HISTORIC PRESERVATION COMMISSION

Date: February 9, 2012

Historic Area Work Permit #588786, window replacement and alterations to house

MONTGOMERY COUNTY HISTORIC PRESERVATION COMMISSION STAFF REPORT

SOUTH ELEVATION
SCALE 1/4"= 1'-0"

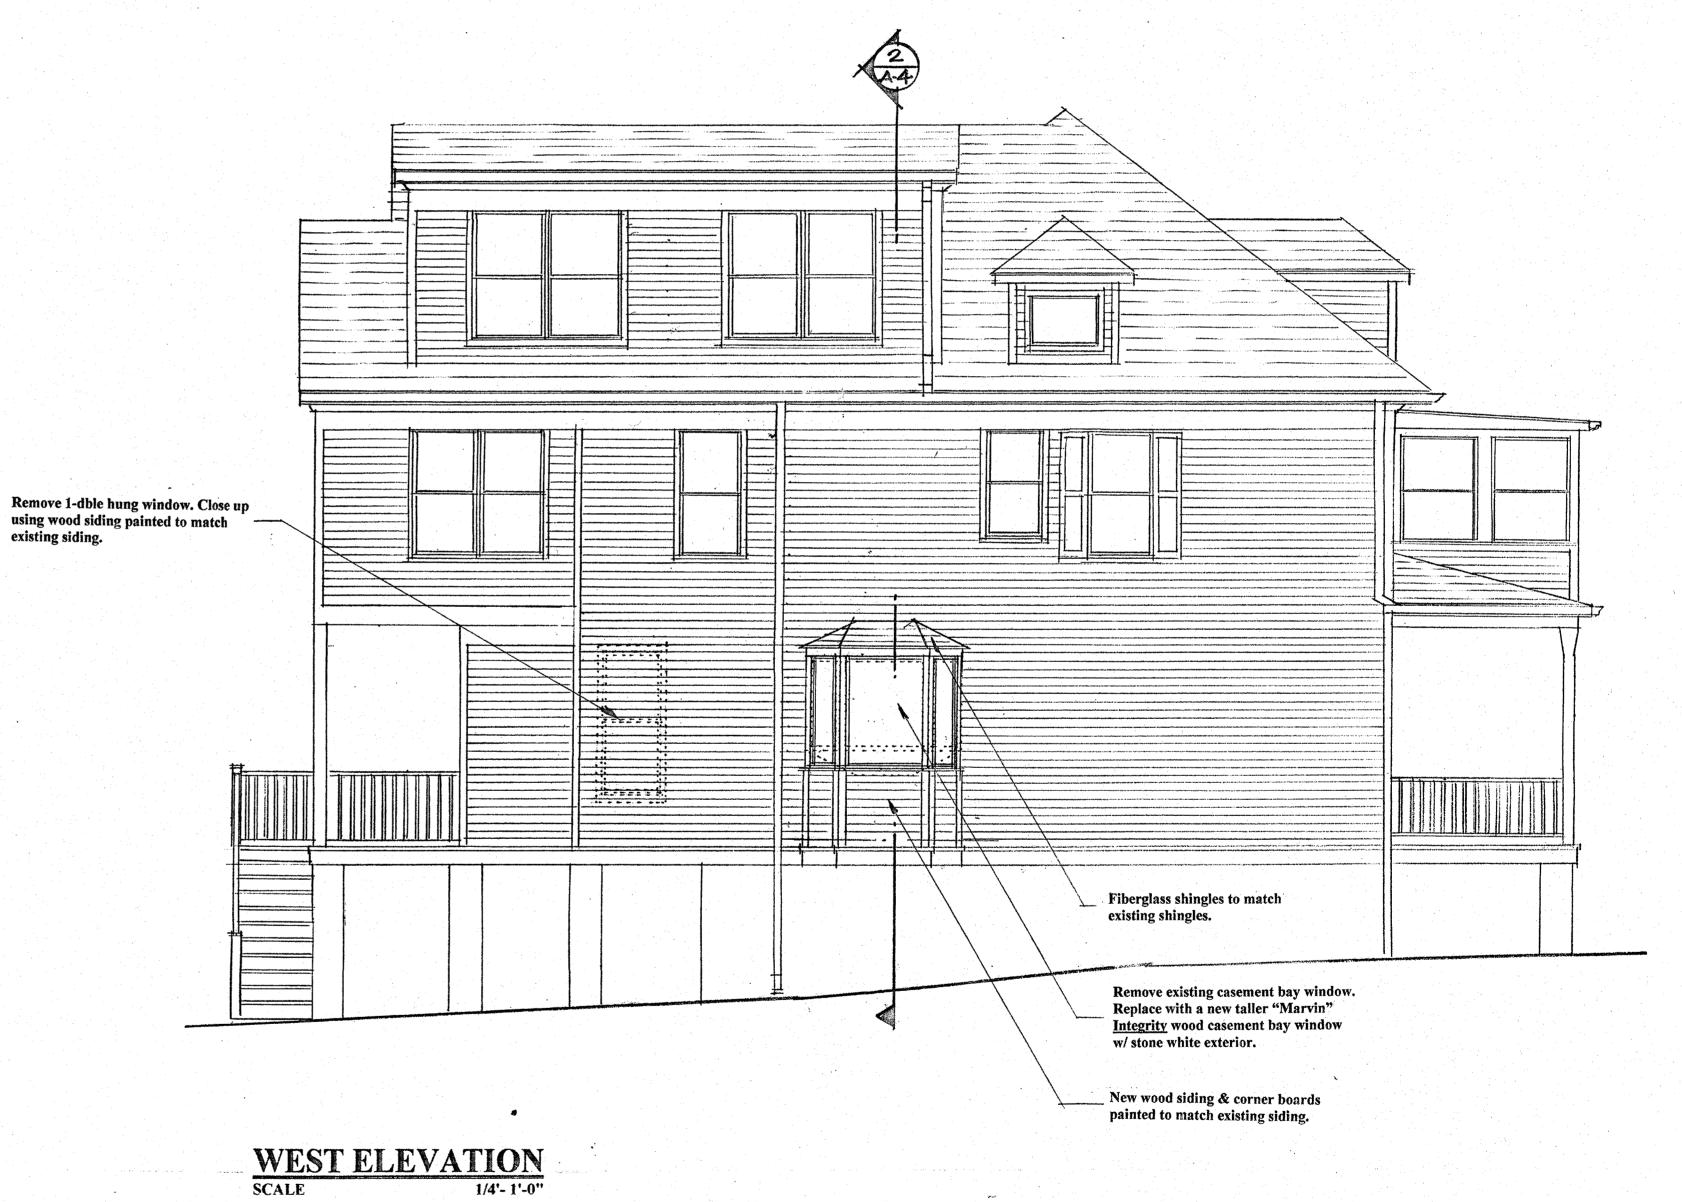
1. The proposed PVC clad exterior wooden casement in the left side (west) elevation of the historic massing is not approved. A wooden (interior/exterior) casement window will be installed in lieu of the proposed clad exterior wooden casement window in this location.

1. The proposed PVC clad exterior wooden casement window in the left (west) side elevation of the historic massing is not approved. An all wood (interior/exterior) casement window will be installed in lieu of the proposed clad exterior wooden casement window in this location.

Staff supports the proposed removal and replacement of the non-historic casement window with a new (taller) casement window in the historic massing. The proposed installation of a slightly taller casement window will not substantially alter the exterior features of the resource and will have negligible impact on the historic massing because this section of the house has already been altered. However, staff **does not** support the installation of a PVC clad exterior wooden window in this location. The subject window is visible from the public right-of-way and within the historic massing. Staff recommends an all wood (interior/exterior) casement window to reflect the character of historic windows found throughout the historic district and for compatibility with the remaining historic windows on the house.
